TECHNICAL NOTE

Date:	10/07/2020	Ref:	402.06594.00008 - TN01 v01
Subject:	Middleton Development – Discharge of Surface Water Drainage Conditions Prepared for: Frontier Estates Ltd

This Technical Note summarises the surface water drainage strategy that has been developed and agreed for the proposed residential development by Frontier Estates Ltd at Yapton Poultry Farm, Middleton-on-Sea, PO26 6DY (Planning M/45/16/PL), in order to discharge planning conditions 11, 13 and 14 of the Planning Consent granted on 07/02/2017.

Figure 1
Groundwater Level at all Boreholes

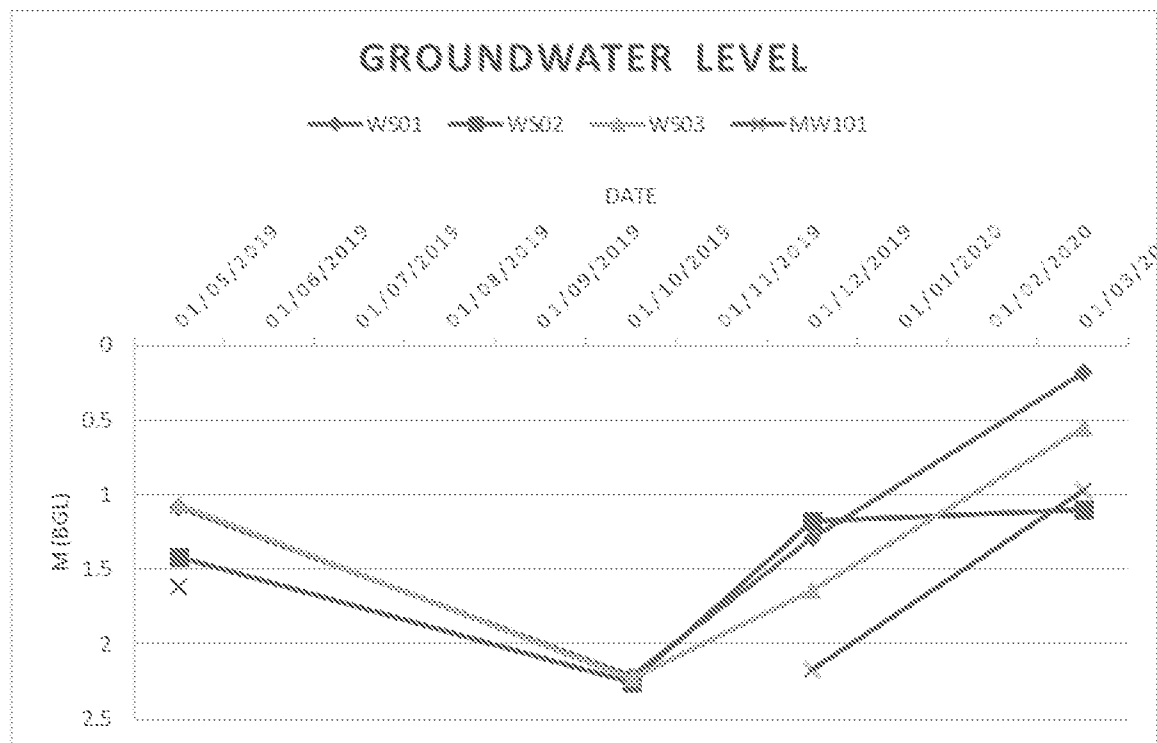
Firstly, we need to be sure that shallow infiltration is not possible, as part of an overall scheme. Please provide a plan showing all the groundwater monitoring point locations and the monitoring results for all, not just WS02. Achieving 1m freeboard between the base of structures and the peak recorded groundwater level is not a requirement in this particular area, so long as the base is above the peak recorded level. This information will dictate as to whether shallow winter infiltration testing will be required.

The results from the manual dip monitoring over the winter period show that the peak water level was 0.18m below ground level at WS01.

Figure 4
 Route 1 Plan and Section AA'

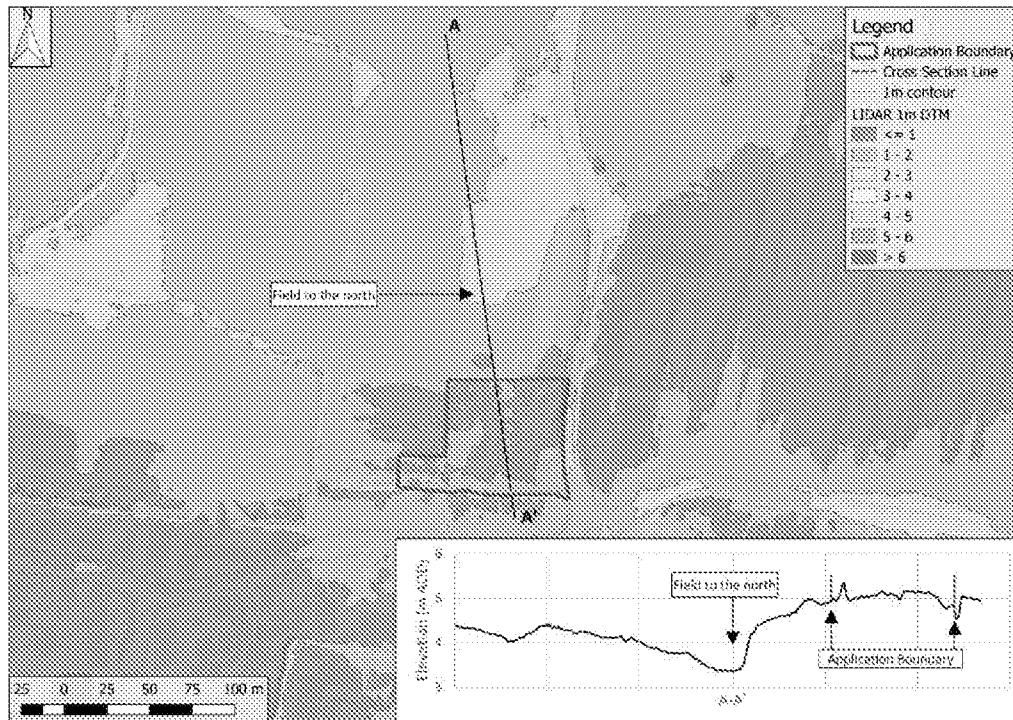
The applicant should also provide topographical evidence to show that no overland/exceedance run off flows from the field to the north will have any detrimental effect on the development/suds."

Ground elevations generally decrease northwards towards the Ryebank Rife, which is located approximately 800m north of the site. As shown in Figure 4, the proposed development is located at a higher elevation (approximately 5m AOD) compared to the field located to the north of the development (approximately 3.4m AOD). Ground elevations immediately north of the field are also situated at a lower elevation than the proposed development, with the highest point situated at approximately 4.4m AOD. Therefore, any surface water ponding in the field will preferentially escape northwards away from the site and back towards the Ryebank Rife.

APPENDIX 03 – SITE ACCESS LAYOUT

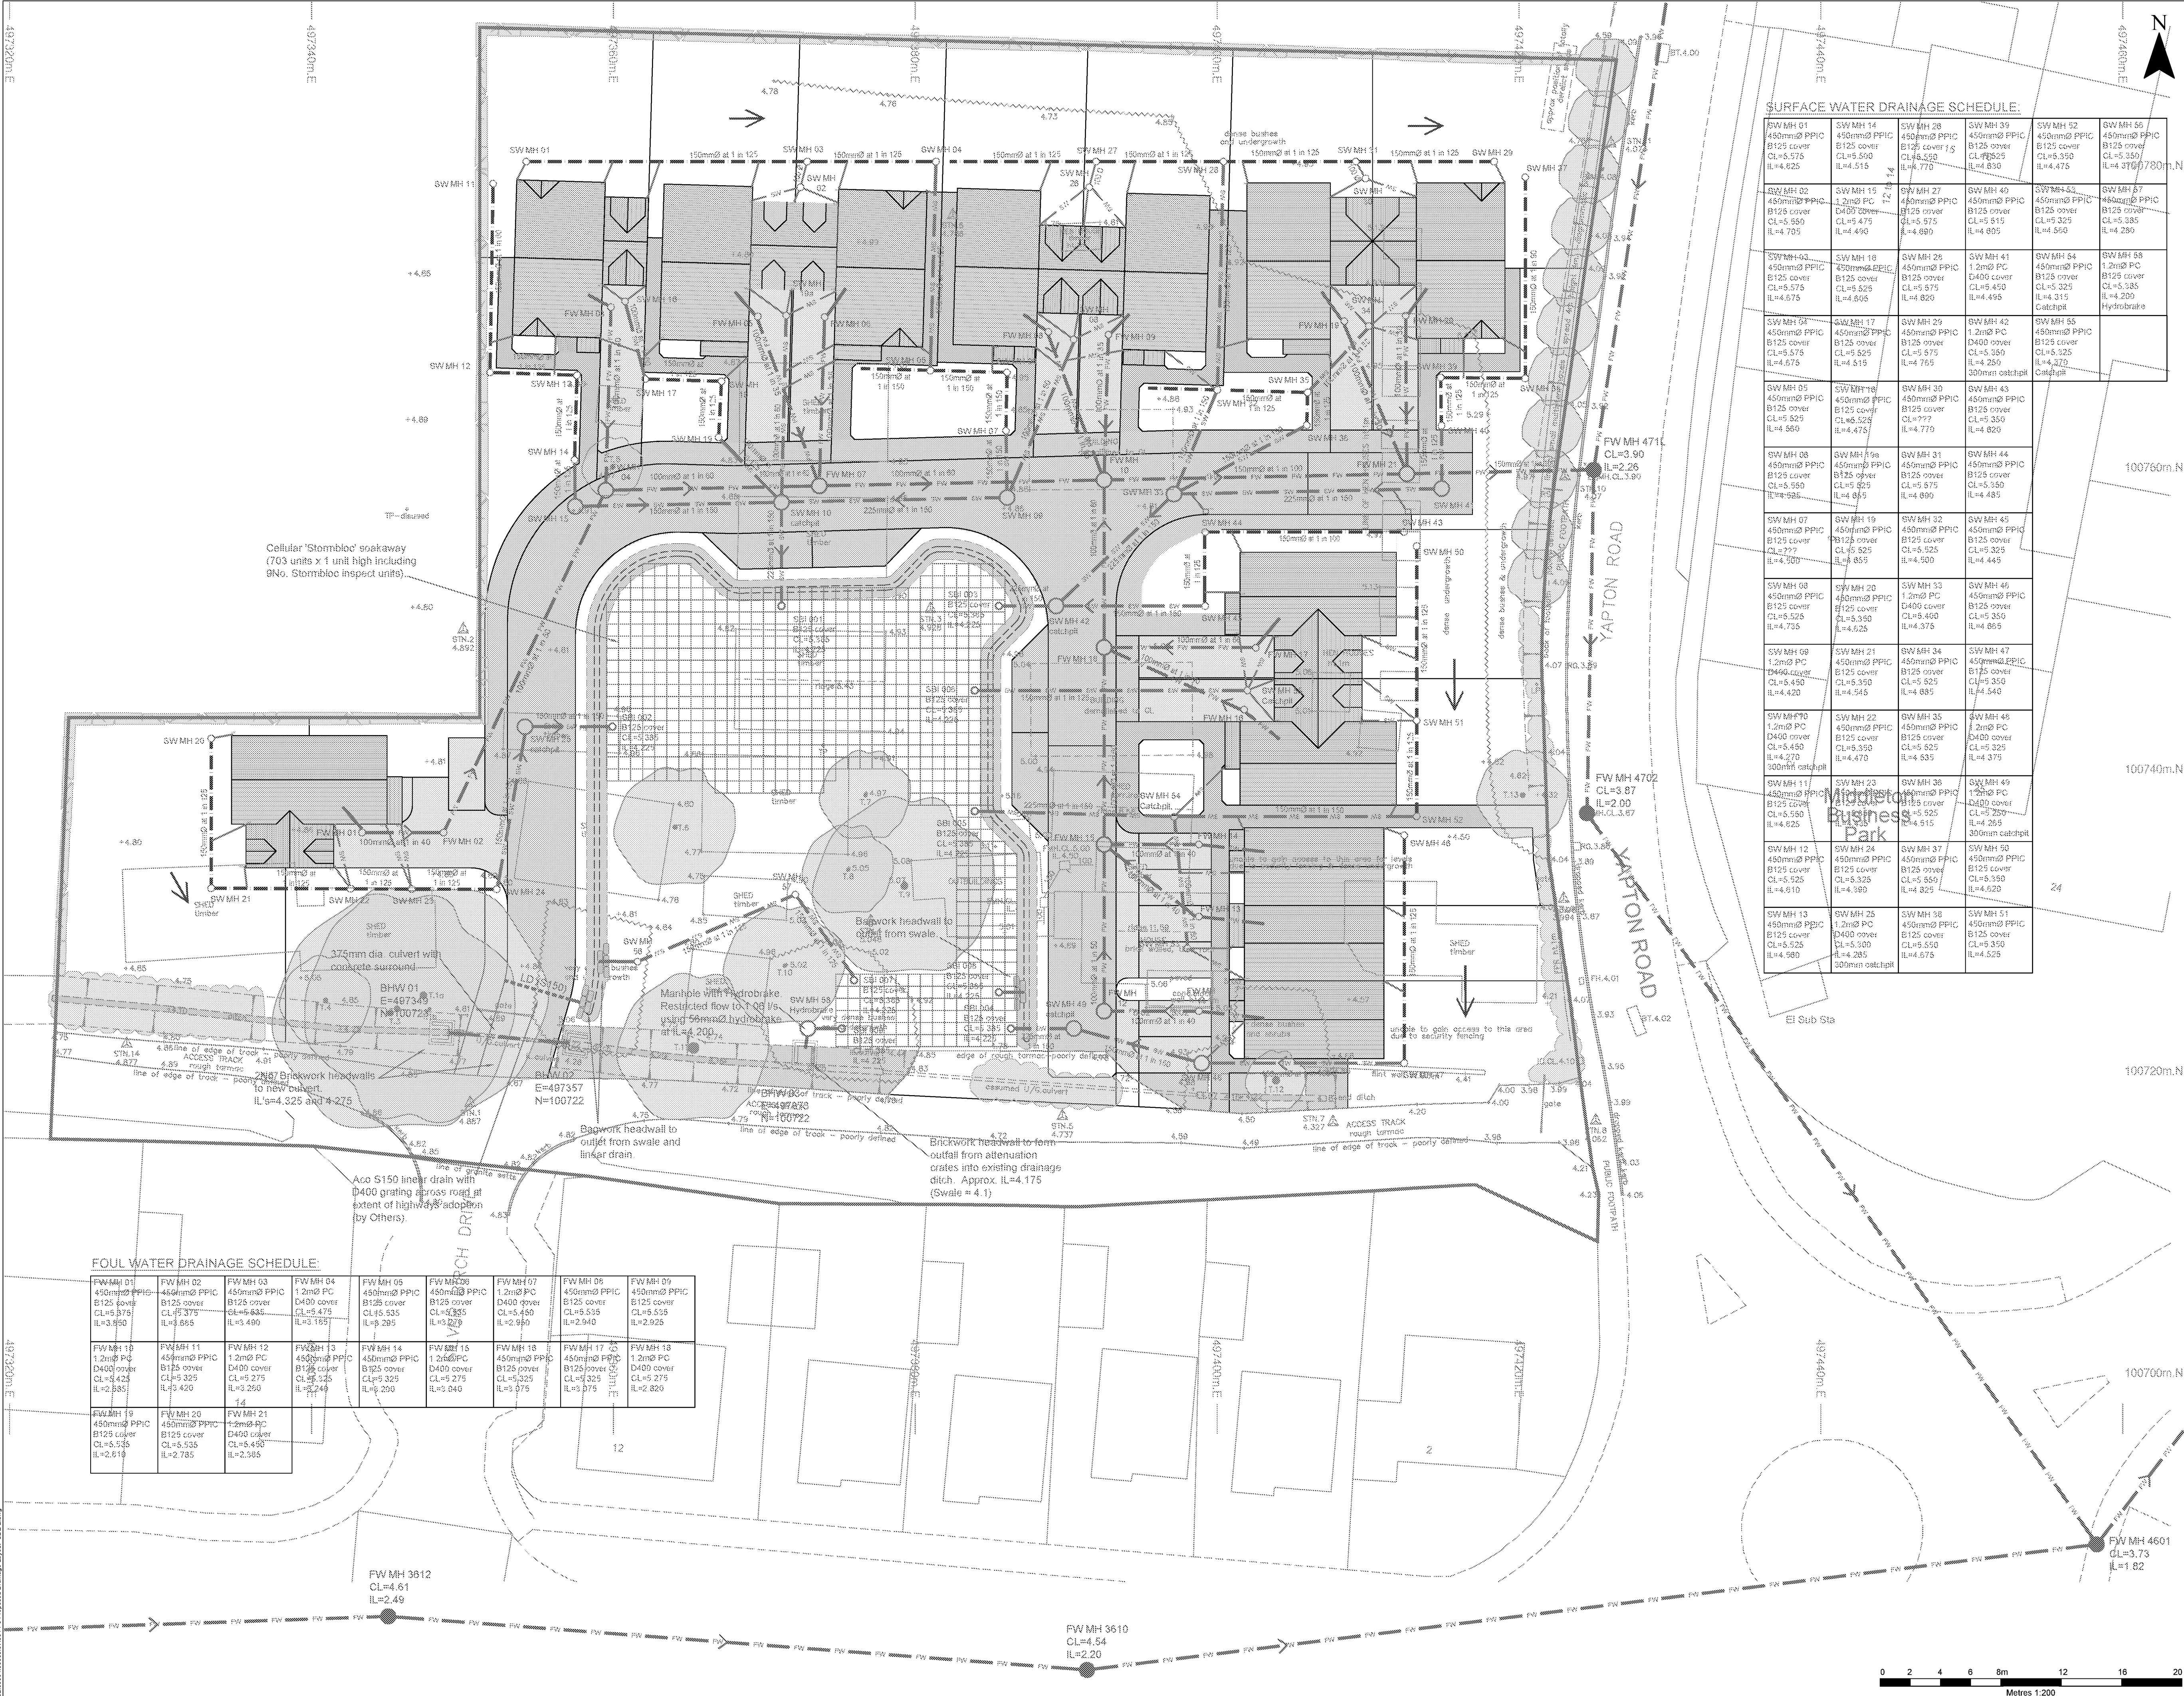
Regarding the ditches on the southern boundary, it is very likely that these will need improvements and I suggest a meeting takes place on site to look at these. Land Drainage Consent will be required for any alterations to them, including culverting and any discharge structures. This will all need to be fully detailed on the drawings.

In addition, the existing culvert beneath the access track is to be extended from 6 metres to 11 metres in order to be sufficient for safe vehicular movements in relation to the development site.

The proposed access layout is shown in **Appendix 03** with the drainage plan and details shown in **Appendix 04**.
